**Sufco Mine**

Re: Amendment in Response to Deficiencies for Task ID No. 4767, Sufco Mine, Canyon Fuel Company, LLC, Permit Number C/041/0002

**Title:** Amendment in Response to Deficiencies for Task ID No 4767

## **HISTORY**

**Illustrating Abatement for NOV 13148(a)**

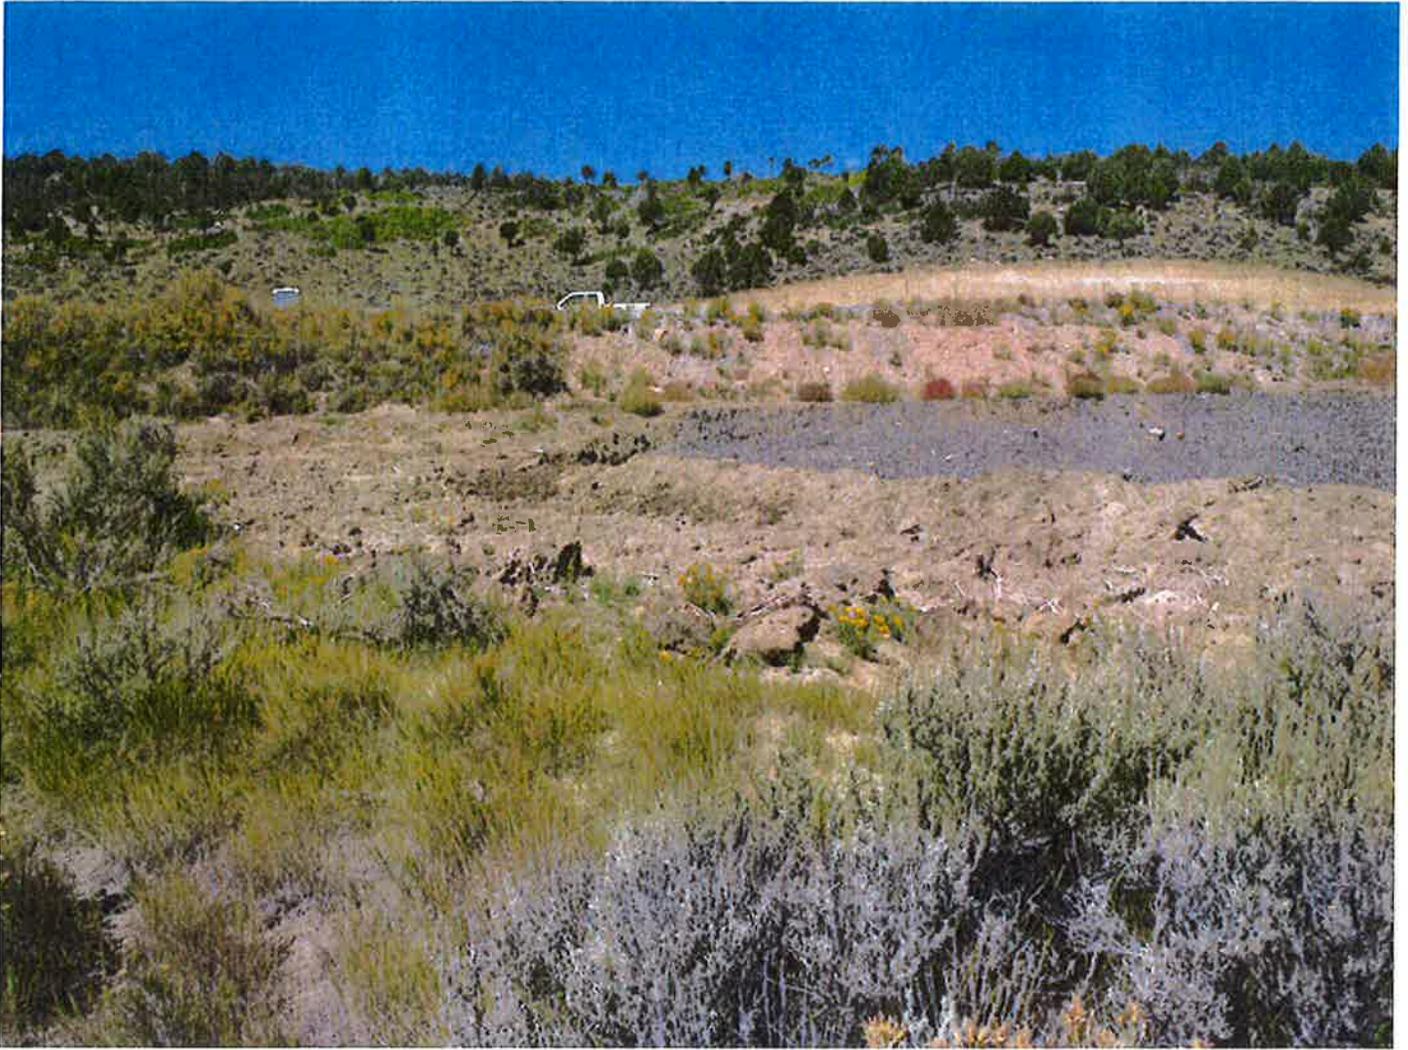
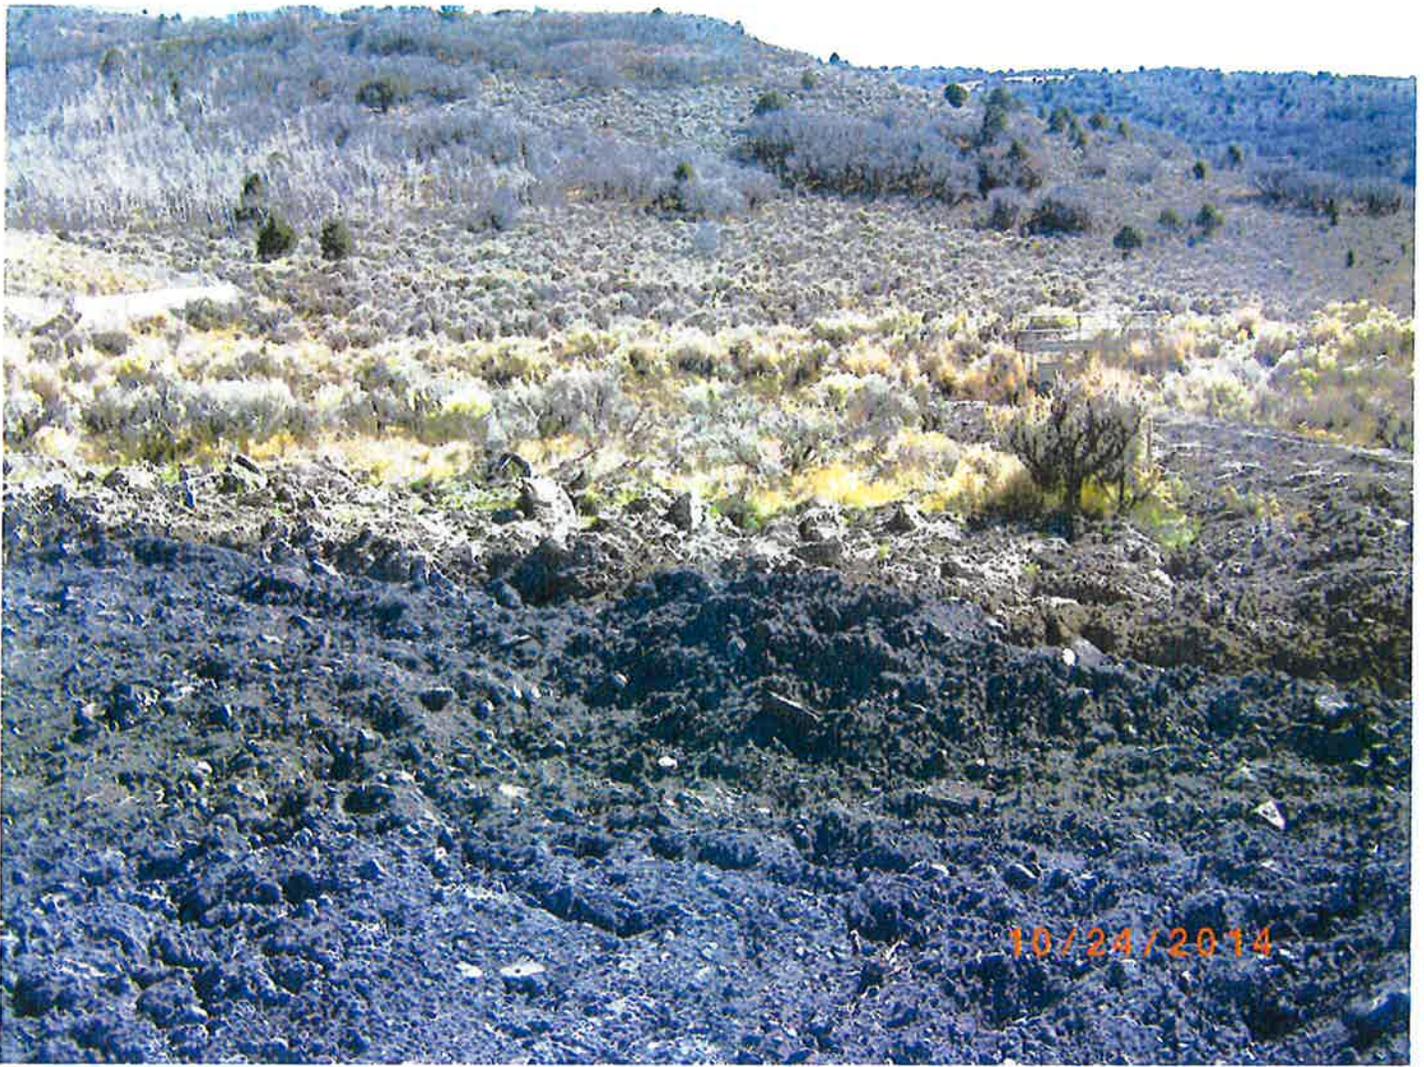
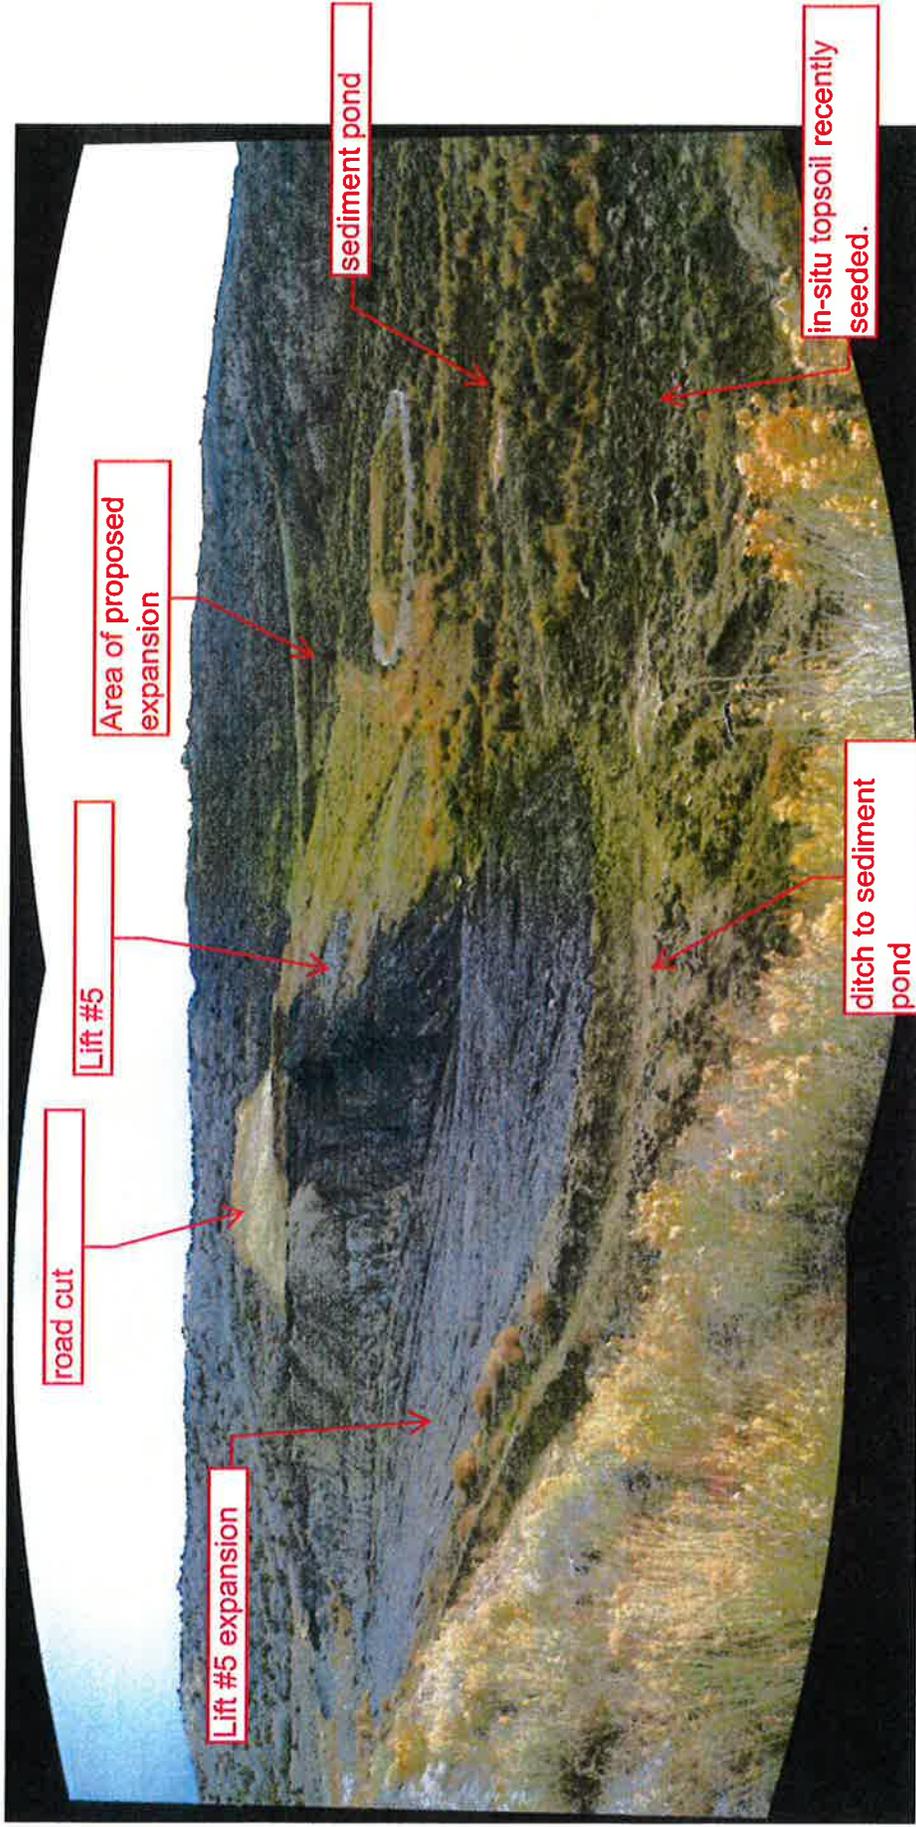
*Stipulation A: Show that pooled surface drainage and stormwater runoff that had been visually observed at the time of the complete inspection has been eliminated or properly conveyed to the sediment pond.*

*Stipulation A: Show that pooled surface drainage and stormwater runoff that had been visually observed at the time of the complete inspection has been eliminated or properly conveyed to the sediment pond.*

Previously provided in amendment on 12/18/14 for inclusion in - WRDS Appendix V

Previously provided in amendment on 12/18/14 for inclusion in - WRDS Appendix V

**Waste Rock Disposal Site**  
**Map of Topsoil Piles 1A & 1B**  
**@ 1" = 25'**

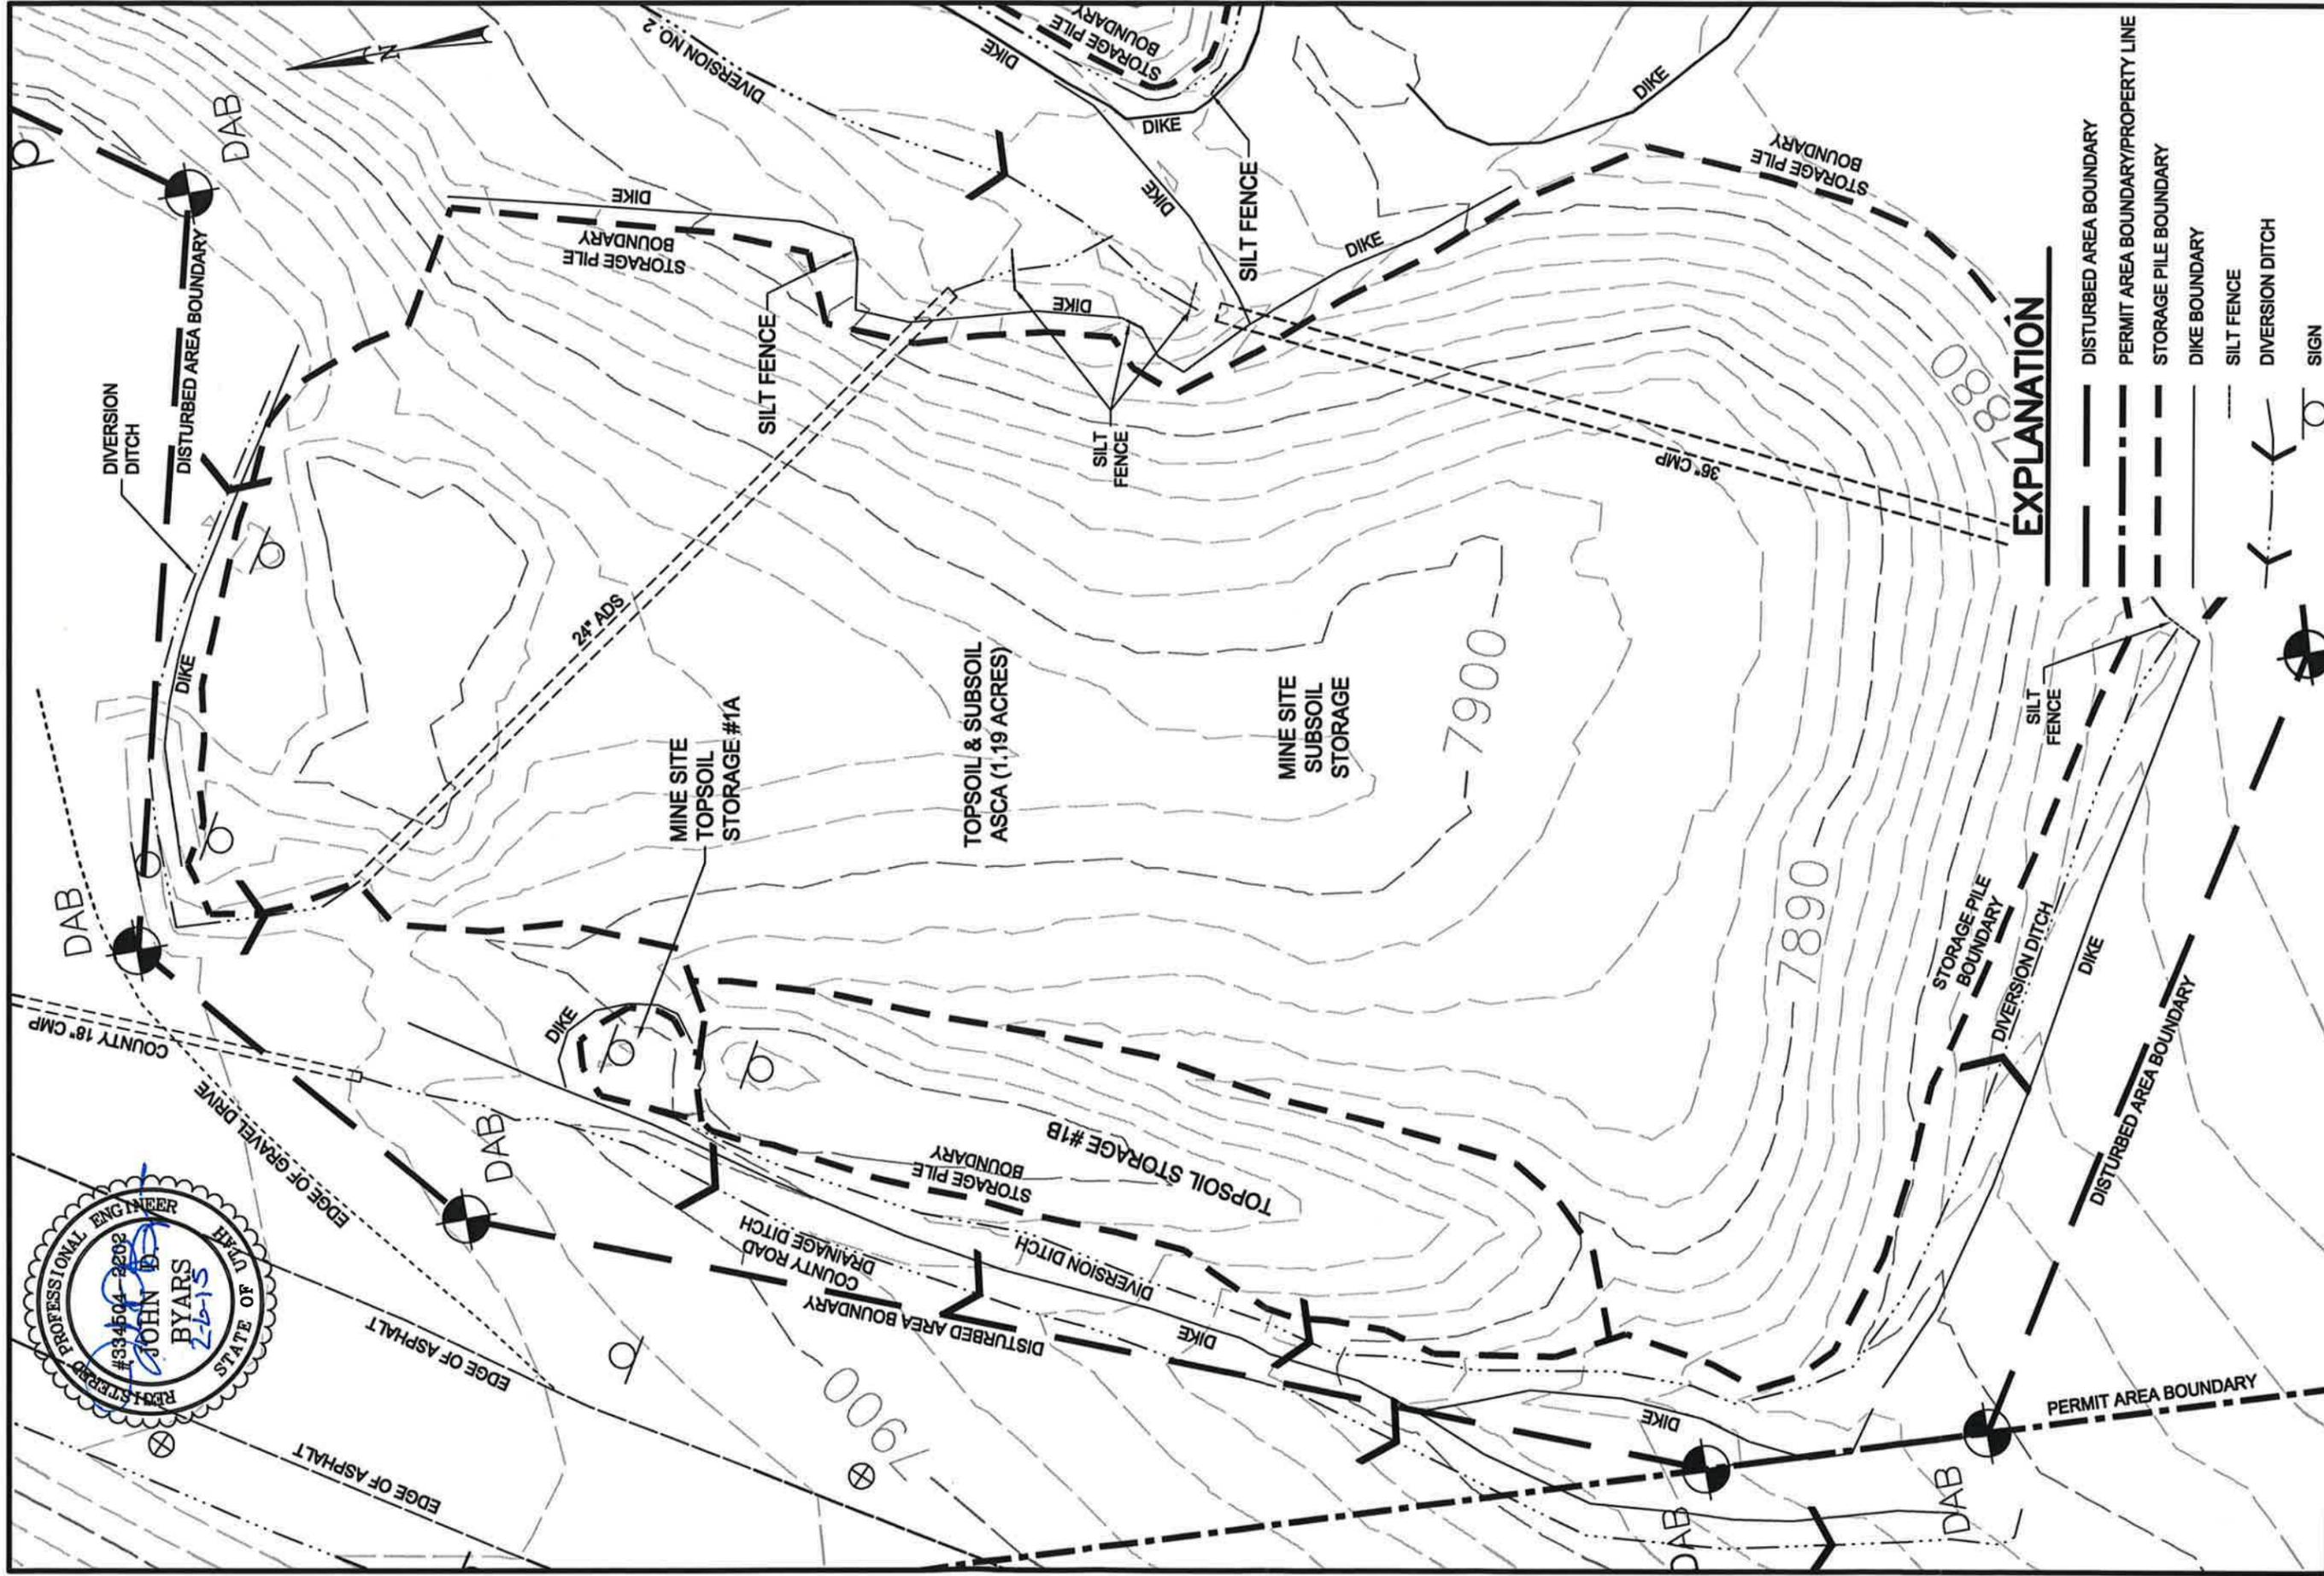
*Stipulation - Submit Map of topsoil storage piles 1A and 1B at a scale of 1"=25' with line types more clearly distinguishing berms, ditches, silt fences and the disturbed area boundary.*

*Stipulation - Submit Map of topsoil storage piles 1A and 1B at a scale of 1"=25' with line types more clearly distinguishing berms, ditches, silt fences and the disturbed area boundary.*

Provided in amendment on 12/18/14 for inclusion in - WRDS Appendix V as Figure 1

Provided in amendment on 12/18/14 for inclusion in - WRDS Appendix V as Figure 1
